Date 13.06.03	Ref. No. 03AH003	Model AM-LM918, LCX-MT22, XR-FD1, XR-FD5, XR-V10MD	HA
Subject "Disc Error" Indication			IRIS C625

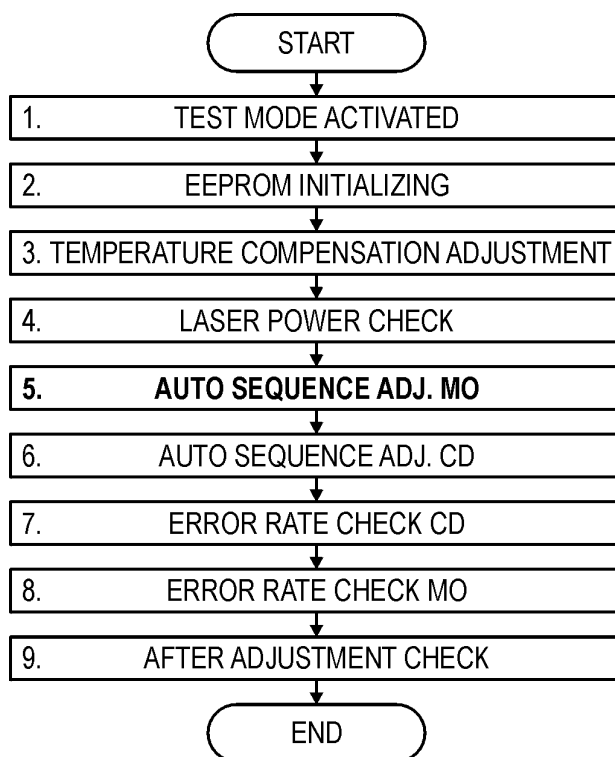
"Disc Error" may be displayed with specific discs such as Sony MD (Neige series), i.e. 5MD74NEA, 5MD80NEA, 10MD74NEA, 10MD80NEA.

Unstable reading when using low-reflectivity MO discs.

Using the test disc **"MDW-74/AU1" (8-892-341-41)**, only perform the "Auto Sequence Adj. MO" (step 5 of the "Adjustment Procedure Flowchart" below).

If the message "Failed" appears during the adjustment, perform the complete adjustment procedure as described in the Service Manual.
